# CHANGE ORDER APPROVAL FORM

PROJECT: NAU WWTF Headworks Rehab  
and Aeration Piping Replacement

CHANGE ORDER: 1

Description: ADD: Replacement of influent fittings, Repair and Relining of Surge Basins, Interior coating of top four feet of remaining basins, and exterior repainting of structure/tanks. REMOVE/CREDITS: Remove coating of Stainless Steel air piping, Credit for alternate rotary drum, Credit for plug/butterfly valve change.

### **NAU Headworks & Aeration Piping Rehabilitation** *Replacement of Influent Fittings*

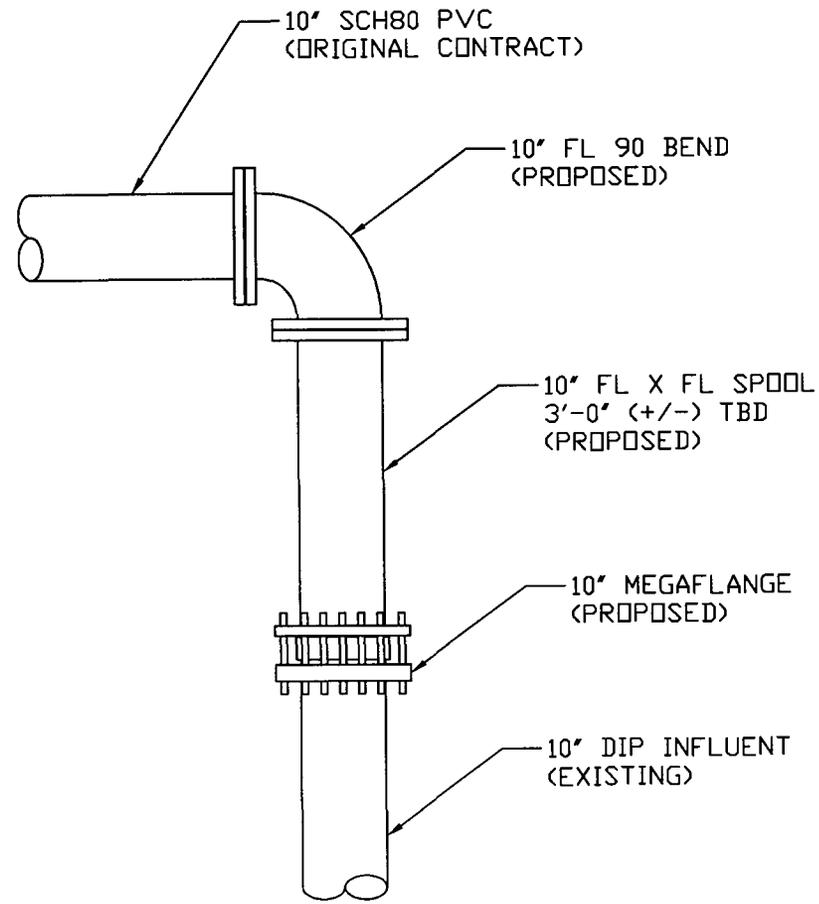
Per the Contract Documents, we are submitting the attached proposal for the replacement of the influent pipeline fittings, including short sections of related pipeline.

This proposal is as requested by NAU staff in response to our observation that the existing 10" flanged 90 fittings and related flanged connection joints on the three (3) influent pipelines have corroded to point of failure. We have further observed that one of the fittings is currently leaking. We propose to replace three (3) existing flanged 90 fittings and also replace short sections of the influent pipeline (see attached drawing).

| • ADD – Pipe & Fittings (attached quote) | Price: | \$ 4,475.86 |
| • ADD – Crew Labor, ½ Day                | Price: | \$ 1,595.00 |

FOR: NASSAU WWTP  
SURGE BASINS

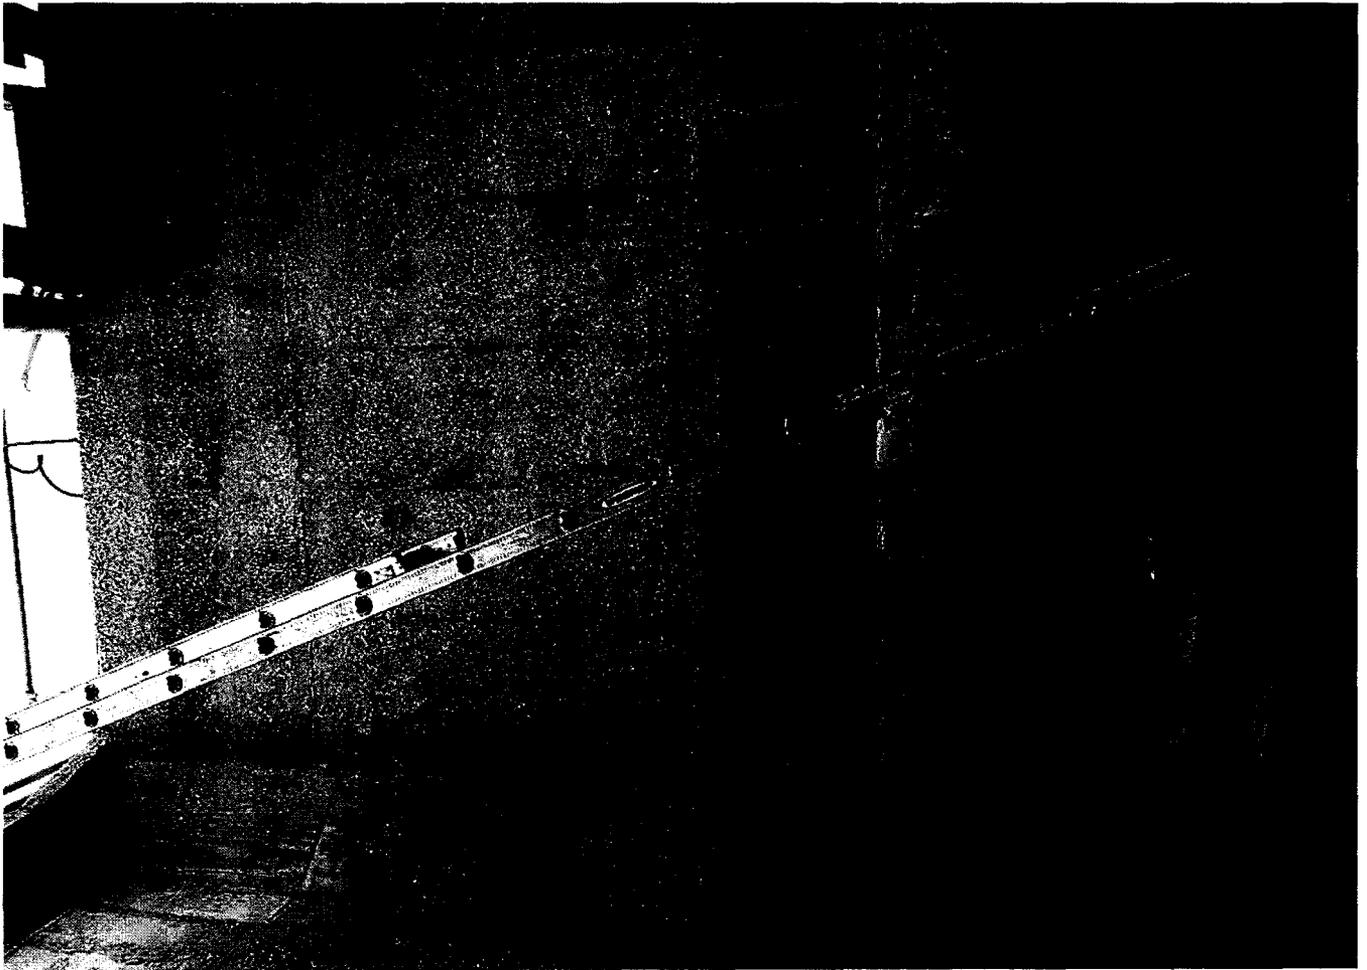
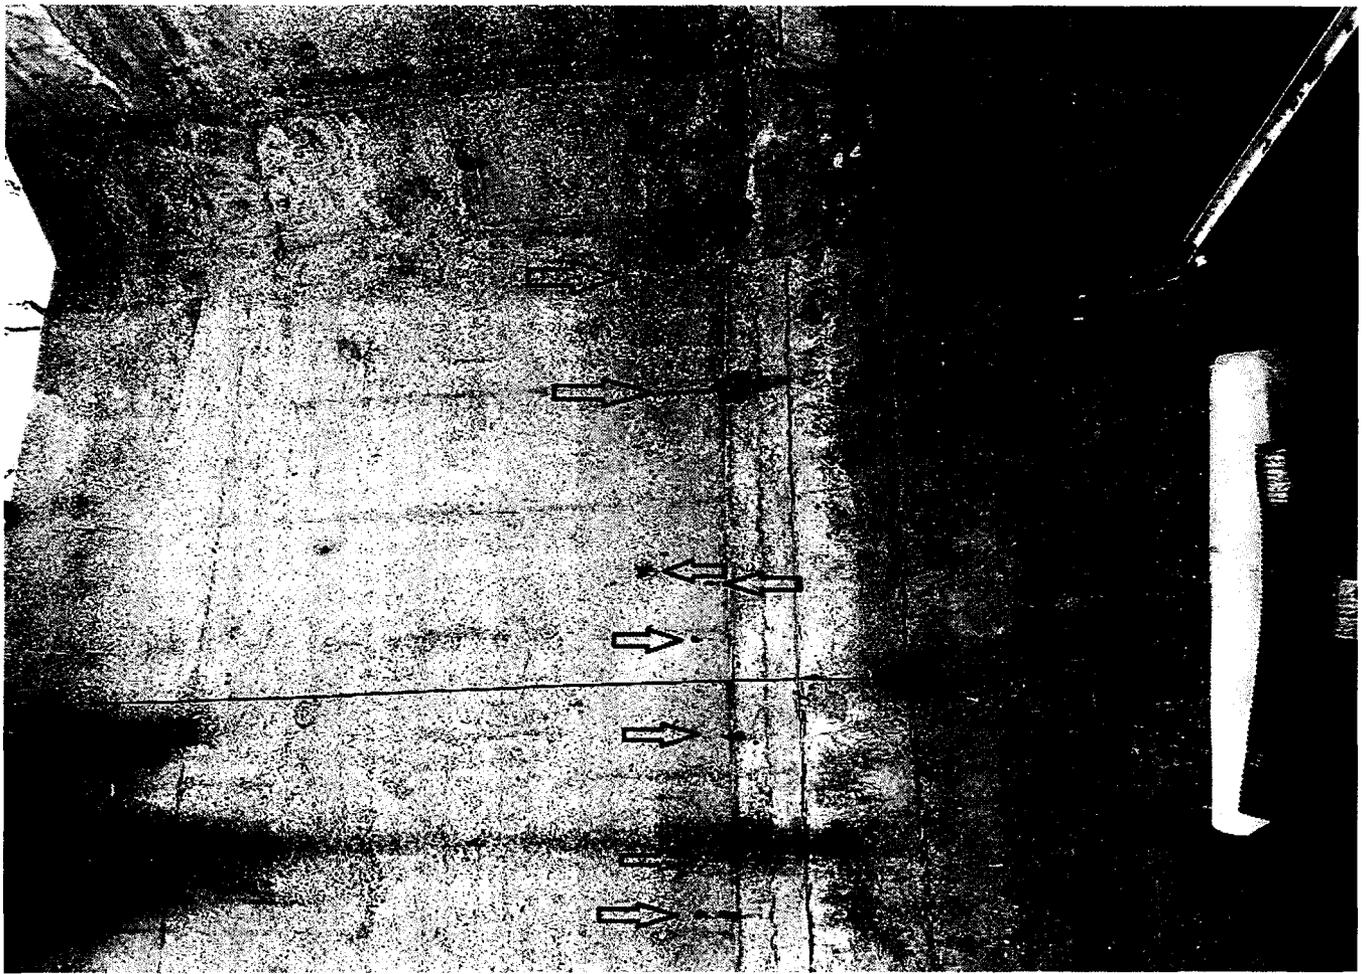
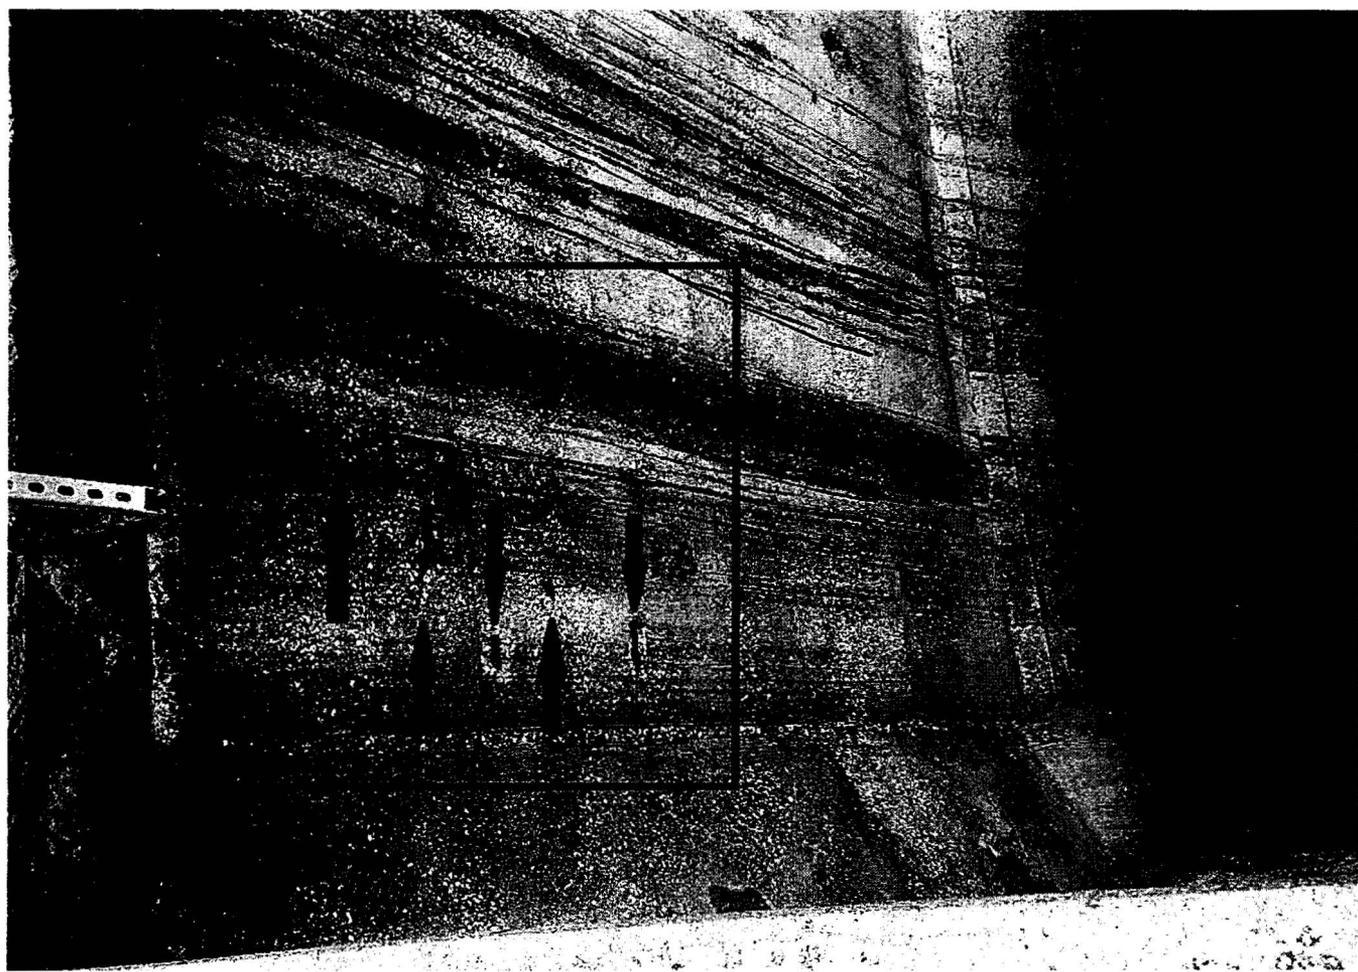
Structural inspection of the surge tanks was recently completed after draining and cleaning occurred. The team has found significant wear to the concrete, including cracks, spalls and overall erosion of the concrete. Per the contract, repairs would occur at \$225 per square foot. However, this cost was not intended for large repair areas or overall methods. For example, repairing/recoating only one-third of the surge tanks surface would cost approximately \$300,000 with this pricing/method.

Upon further evaluation and discussion, the team recommends implementation of an alternative repair/coating process as a more cost effective solution. The alternative considers repairing and applying an epoxy coating system to the entire surge tank internal walls. This option will provide a complete rehabilitation of the internal structure walls, and also provide a protective epoxy to extend the life of the tanks. Provided the wear which has occurred on the tanks, providing only concrete repairs will result in continued wear and erosion of the surface, thus requiring more significant rehabilitation in the future. The epoxy coating system is intended to prevent wear of the concrete by acting as a protective barrier. It also minimizes adhesion of solids to the surface and allows for easier cleaning.

The epoxy coating is anticipated to last 10-15 years. At that point, a recoat can be applied as preventative maintenance and renew the life. This will reduce costs by protecting the concrete and avoiding significant restoration as is currently required. Additionally, the manufacturer provides a 1 year warranty, and will provide any repairs which are needed upon an inspection before the warranty is complete.

- Pressure wash and sandblast all wall surfaces to remove loose concrete and foreign materials.
- Resurface walls with Tnemec Series 217 Mortar-Crete, minimum ¼" thickness.

- *ADD – Coatings as described above* Price: \$ 53,812.00 (per basin)  
(Based on subcontractor price of \$51,250 PLUS contractor's 5% Fee)

DESCRIPTION	AMOUNT
REPAIR AREAS OF EXPOSED REBAR AND PLACE TNEMEC SER 217 IN AREA COAT EXPOSED REBAR WITH TNEMEC SER 1 PRESSURE WASH AND SANDBLAST TO CSP 4  RESURFACE WALLS WITH TNEMEC SER. 217 FOR 1/4" MIN. DEPTH ONE COAT OF TNEMEC SER. 66HS 2 COATS OF TNEMEC SER. 61  NOTE: ONLY INCLUDES WALLS AND FEATHERING DOES NOT INCLUDE REPAIR OF OTHER CONCRETE DAMAGE NOT ON WALLS SURGE TANK ONLY, ROUGHLY 2000 SF PER TANK  <u>PRICE IS PER SURGE TANK, SO DOUBLE PRICE FOR BOTH TANKS</u>	
<b>TOTAL</b>	<b>\$ 51,250.00</b>

FOR: NASSAU WWTP  
AERATION BASINS

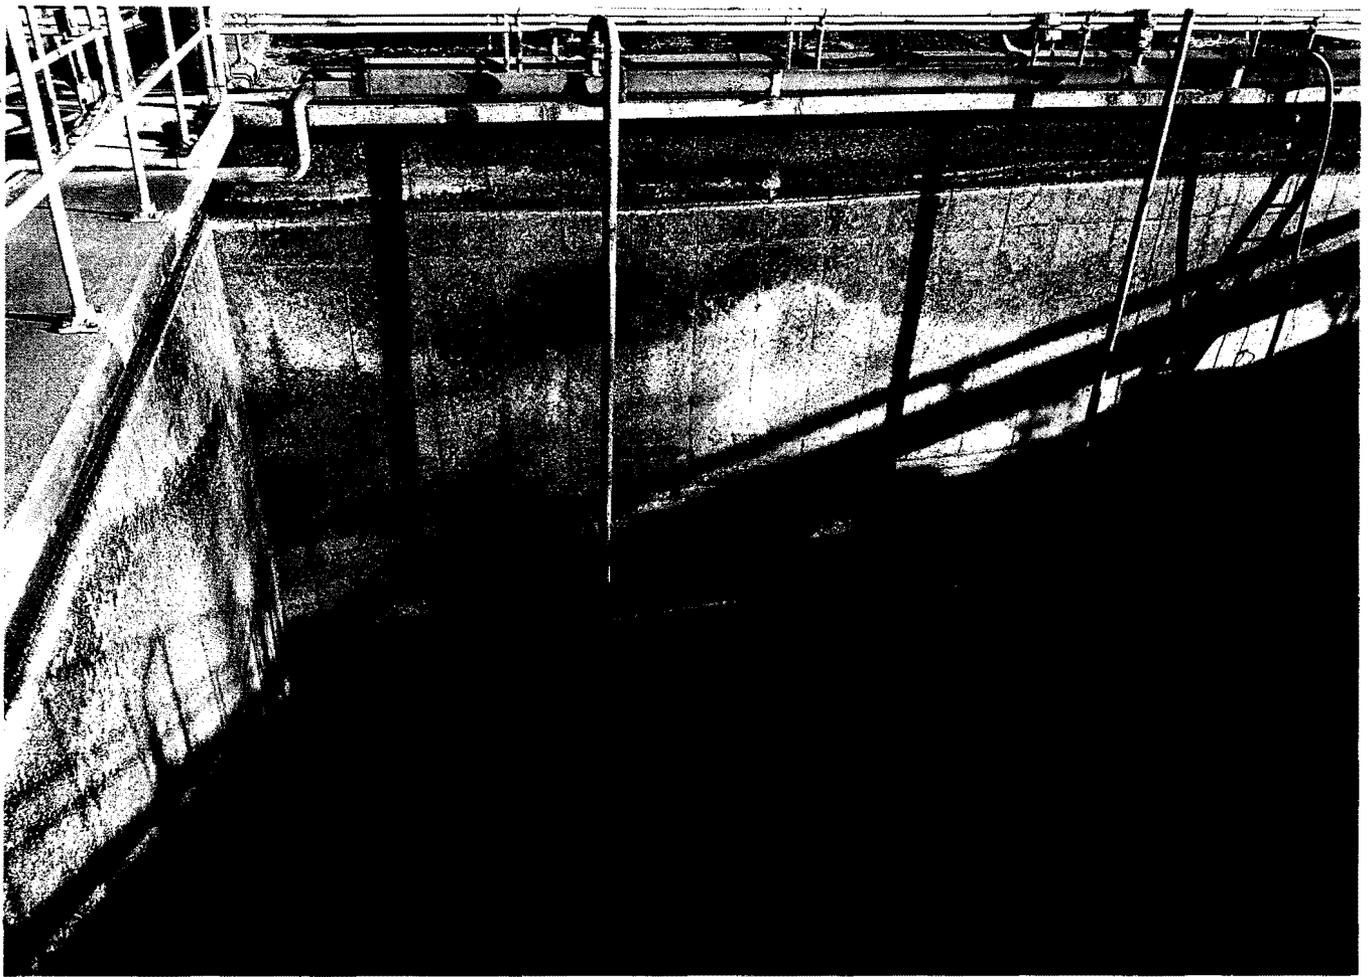
For the remaining process/aeration basins, we recommend the application of an epoxy on the upper portion of the basins. These basins are in much better condition overall, primarily because they remain full at all times. As is typical with wastewater facilities, we recommend coating the upper portion of the tanks (near water surface) to protect the concrete from further wear, protecting the concrete surface from wear, and minimizing the need for future repairs.

- Pressure wash and sandblast walls (upper 4') to remove loose concrete and foreign materials.
- Two coats of Tnemec Series 46H-413 on the upper 4' of wall surfaces.
- Includes misc. minor spall repairs with Tnemec Series 217 Mortar-Crete in upper 4' area

- *ADD – Coatings as described above, PER TRAIN* Price: \$ 28,850.00
- *ADD – 2% bond premium (orig. contract price exceeded)* Price: \$ 577.00
